Site Accessibility Evaluation

Environmental Building

**3255 Akers Dr
Colorado Springs, CO
80922**

Accessibility Evaluation

Finding 117888 Main Photo

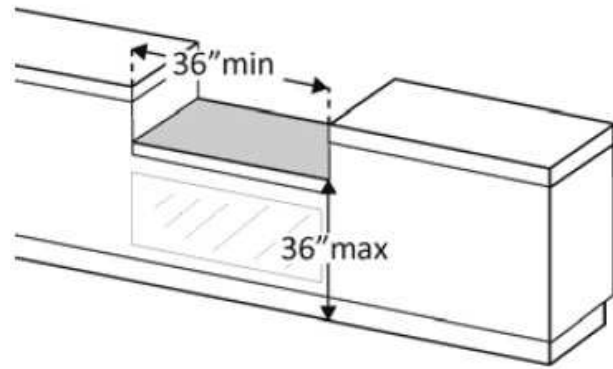
The transaction counter is too high.

Counter measured at 42.5 inches from surface to floor.

Modify or extend existing service counter or install new counter/section that includes a section of counter surface that is 36 inches long minimum and 36 inches high maximum.

Finding 299176 Main Photo

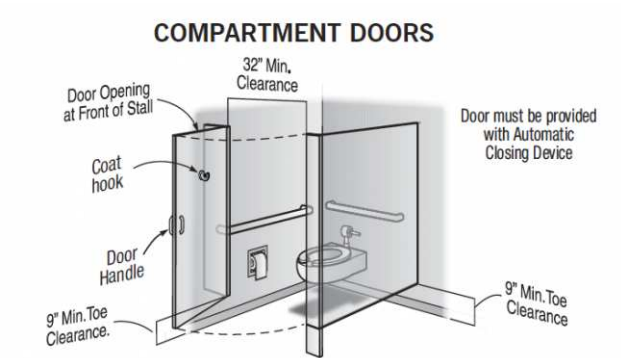
The compartment door is not self closing.

Compartment door not self-closing

Adjust or install automatic closing hinges.

Finding 299182 Main Photo

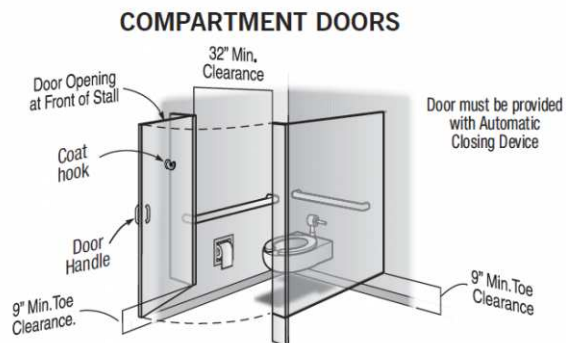
The compartment door is not self closing.

Compartment door not self-closing

Adjust or install automatic closing hinges.

Finding 299188 Main Photo

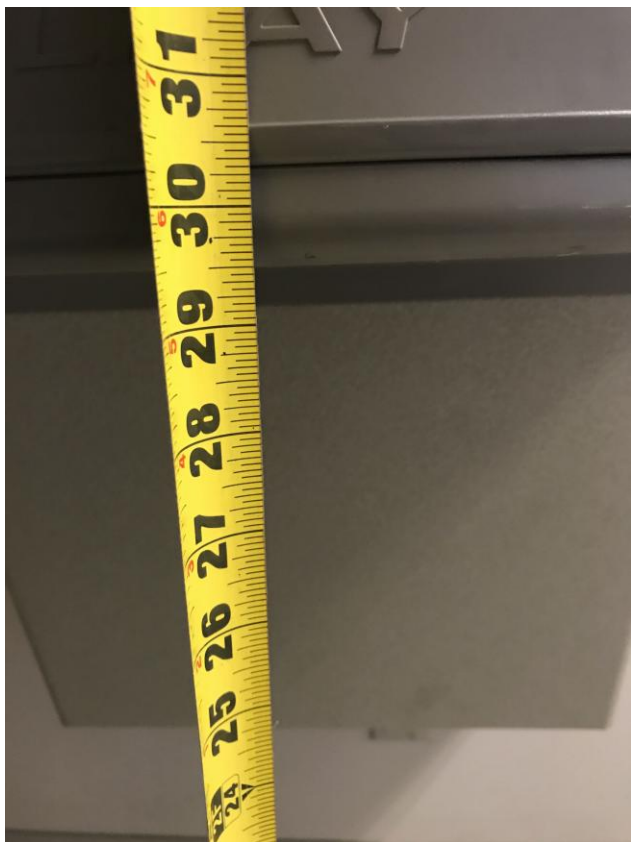
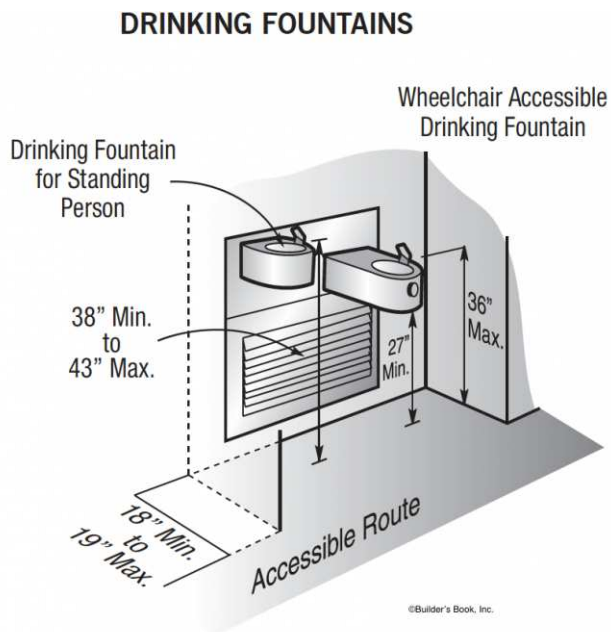
The drinking fountain is not accessible.

Drinking fountain protrudes into circulation pathway and not cane detectable

Adjust drinking fountain height to provide exactly 27 inches of clearance or install wing walls, planter or permanent fixture next to drinking fountain in order to make it cane detectable.

Also, adjust spout/water pressure to provide a flow of water 4 inches high minimum.
